**ITEM 9.2                      PROPONENT INITIATED PLANNING PROPOSAL - 171-179 GREAT NORTH ROAD & 1A-1B HENRY STREET, FIVE DOCK****Reporting Manager      Senior Strategic Planner****Manager Strategic Planning**

To provide Council with the outcome of the assessment of a Planning Proposal relating to 171-179 Great North Road & 1A-1B Henry Street, Five Dock and seek Council endorsement to submit the Planning Proposal to the Department of Planning, Housing and Infrastructure (DPHI) seeking a Gateway Determination.

Figure 14: Proponent proposed building heights

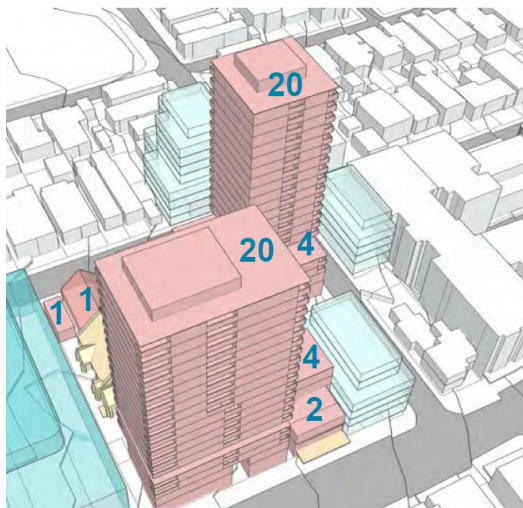
The Planning Proposal is seeking to change the maximum building heights in the LEP from 15m to a maximum of 75m, to facilitate two proposed 20-storey towers. This could increase to 97.5m (26 storeys) under clause 18 of the Housing SEPP where 15% affordable housing is provided.

Whilst the location of the Metro Station adjacent to the site represents an opportunity for increased development, it is not justification for the 75m maximum height proposed and two towers of that height. The scale of the proposed 75m towers is out of context with the existing and desired mid-rise character of the Five Dock Town Centre (and with the heights proposed in the EIE for low- and mid-rise housing). If the forecast heights are compared with the illustrated heights in the Planning Proposal, it is apparent that the proposed towers will be out of context within the future town centre.

The proposed 75m maximum building height is not supported.

Figure 15: Maximum building heights considered by the LPP report

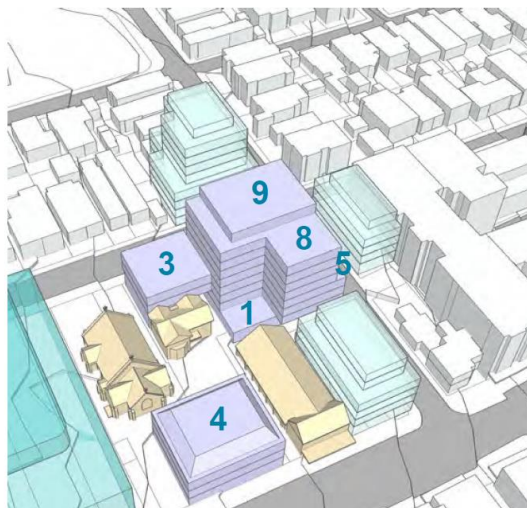
Figures 14 and 15 illustrate the proposed building heights (proponent), and the concept recommended by Council officers and considered by the LPP.

Figure 18: Proponent Planning Proposal – built form

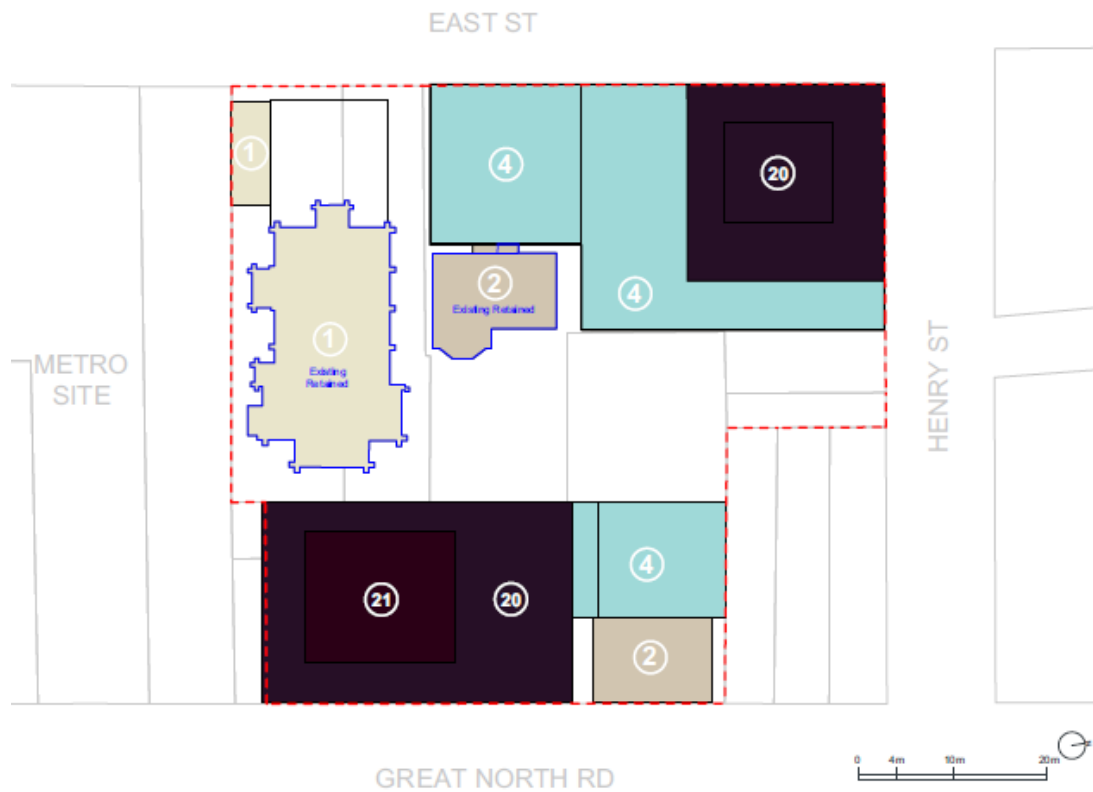
The Planning Proposal request to amend the maximum FSR standard from 2.5:1 to 4.5:1 is not supported.

The retention of heritage building on the site, combined with the concept considered by the LPP for built forms of up to 9 storeys, achieves an FSR of approximately 1.73:1. Whilst, this built form tested FSR is lower than the current permissible FSR of 2.5:1, this outcome is expected given the constraints associated with low the scale heritage buildings on the site and limits on development before the overshadowing Fred Kelly Place.

Retaining the existing maximum FSR of 2.5:1 is therefore recommended.

Figure 20: Level 4-podium (Proponent's Urban Design Report)

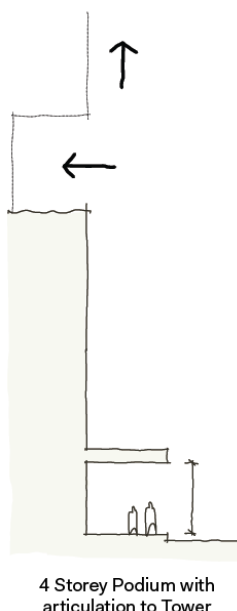
While the proposed podium is no taller than the transept of the church, the single level setback of the fifth storey, where the upper levels (storey 6 to storey 20) are cantilevered and built to the podium edge, means that the bulk and scale of the building dominates the heritage context.

*Figure 27: Mid-winter shadows in Fred Kelly Place - Proponent proposal*

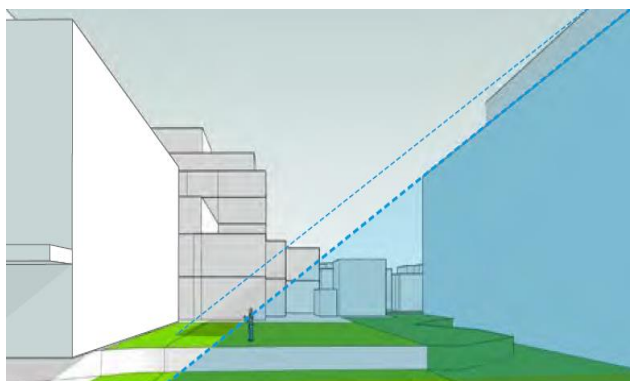
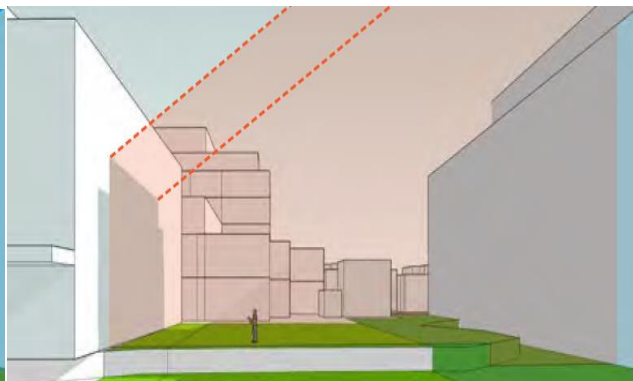
The proposed 75m heights of the 2 towers, which could potentially increase to 97.5m under Clause 18 of the Housing SEPP, will result in overshadowing of Great North Road, the surrounding local streets and the proposed new Town Square, which will comprise a wider Fred Kelly Place and future Plaza on the eastern side of Great North Road.

The alternative floor space ratio, building height and building envelope in the Council officers' report as considered by the LPP, will enable a satisfactory level of solar access to surrounding open space and properties.

Figure 28: Proposed Basement and deep soil (Landscape Report)

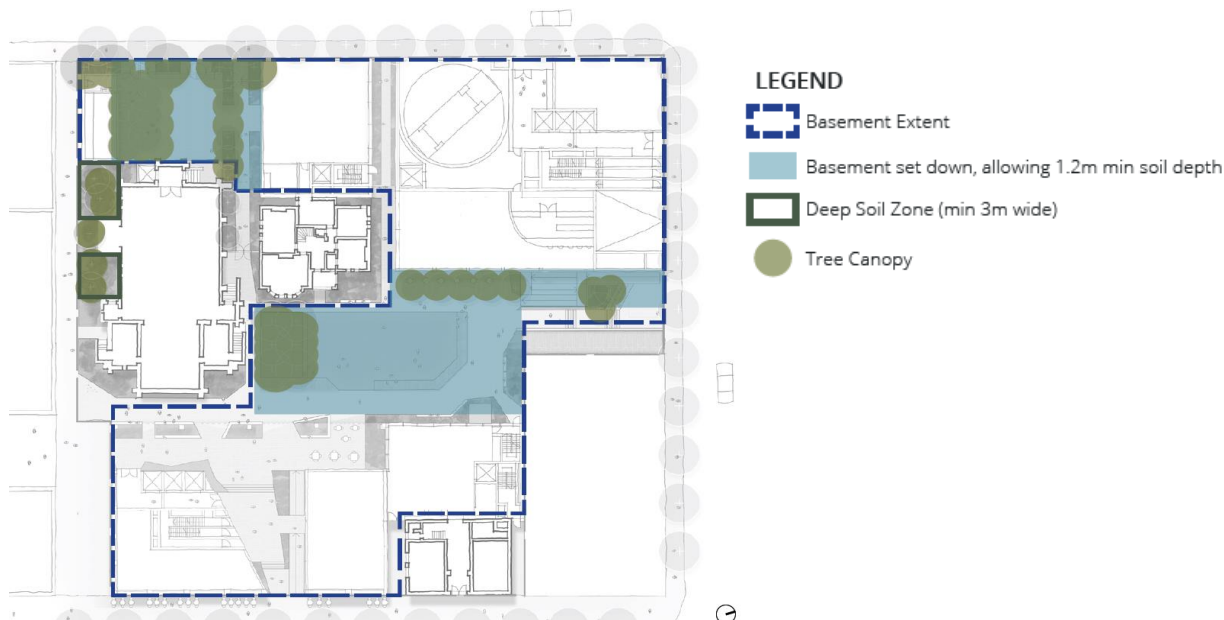
The Planning Proposal has reduced the amount of deep soil on the site from approximately 30% to approximately 1% and reduced tree canopy coverage on the site from approximately 17% to approximately 10%. Most of the proposed trees are located over basement car parking and the trees shown in front of the entry to the Church off East Street are proposed to be located within a 'Covered Space'.

The Planning Proposal Reference Scheme with its proposed tall towers, scale of development, basements and extent of hard urban surfaces is likely to increase the micro-climate temperatures and exacerbate the urban heat island effect. No effort has been made to design around the significant tree, other existing trees and the deep soil areas currently on site.

The Planning Proposal Reference Scheme's outcome of 1% deep soil zone and 10% tree canopy coverage on the site is insufficient. The alternative scheme in the Council officers' report considered by LPP will enable approximately 10% deep soil to be provided on the site.

Figure 29: Proposed through-site links.

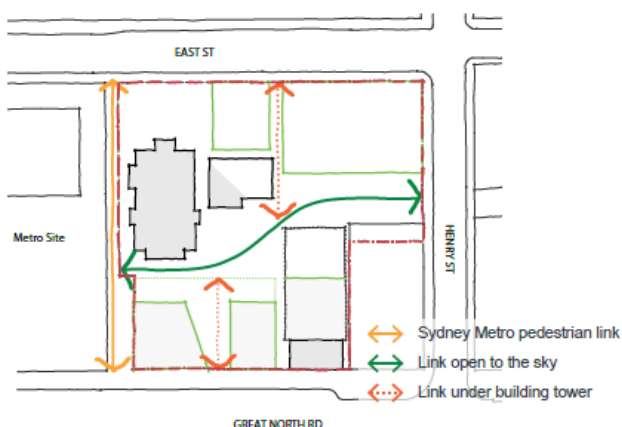
The Planning Proposal makes a number of references to the provision of a north-south pedestrian through-site link that connects directly between Henry Street and the metro site. Information released by Sydney Metro confirms that a single station entry is proposed from the south off Fred Kelly Place.

Three pedestrian links are proposed within the site boundary, none of which provide a direct line of sight from one end to the other. This significantly restricts visual permeability and impacts safety and security for pedestrians.

It is recommended that the Planning Proposal supplement and enhance the Sydney Metro east-west link by making the space an open and uncovered landscaped setback to the Metro pedestrian link and by relocating the proposed Kitchenette and WC.

Figure 30: Through site links considered by the LPP report

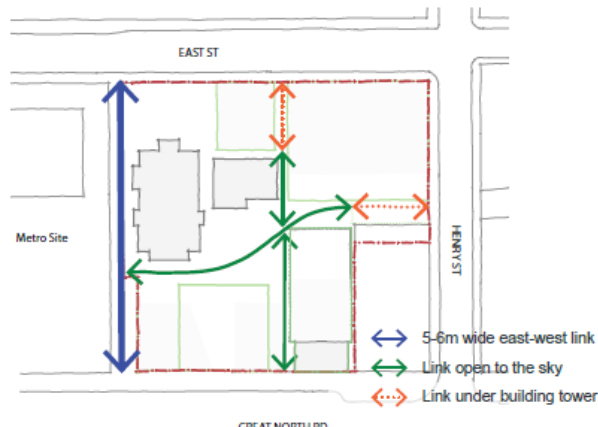
The alternative scheme outlined in the Council officers' report and considered by LPP includes revised through-site links to improve visual permeability by connecting the two east-west links. The revised scheme also enhances wayfinding for pedestrians by reducing the number of under-building pathways, where pedestrians are concealed.

Figure 31: Proponent proposal

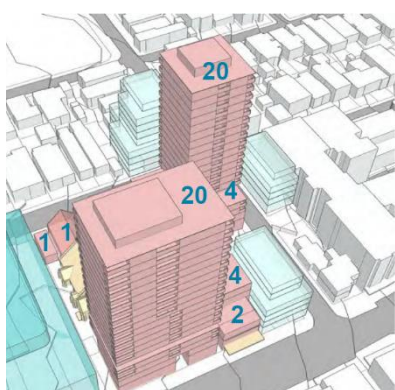
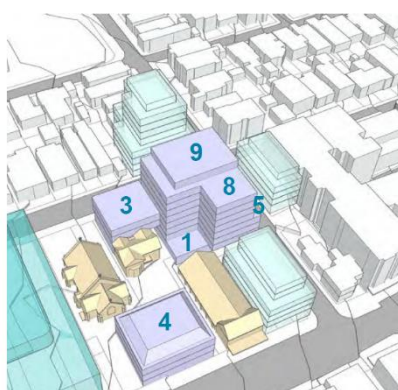
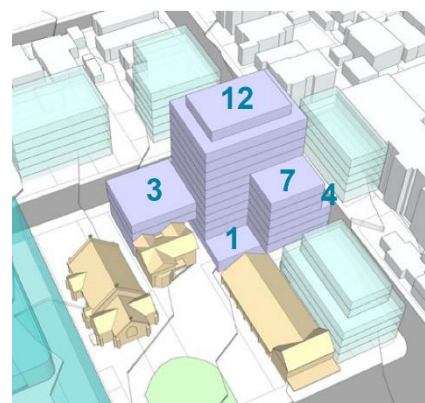
Following consideration of the discussion of the proposal by the Local Planning Panel, Council officers commissioned further analysis from Studio GL. Advice was specifically sought regarding the consequences of relocating the gross floor area that would have been located within the 4-storey building on Great North Road, considered by the LPP, to the residential tower in the north-western corner of the site. This analysis was sought to determine whether it was possible to retain the landscaped area in front of the church, whilst retaining the same quantum of floorspace recommended by Council officers and considered by the LPP, without adverse impacts on Fred Kelly Place or surrounds.

The relocation of the floor space will result in a maximum building height of 39.5m (12 storeys) in that part of the site and no change to the FSR in the Council officers' report considered by the LPP.
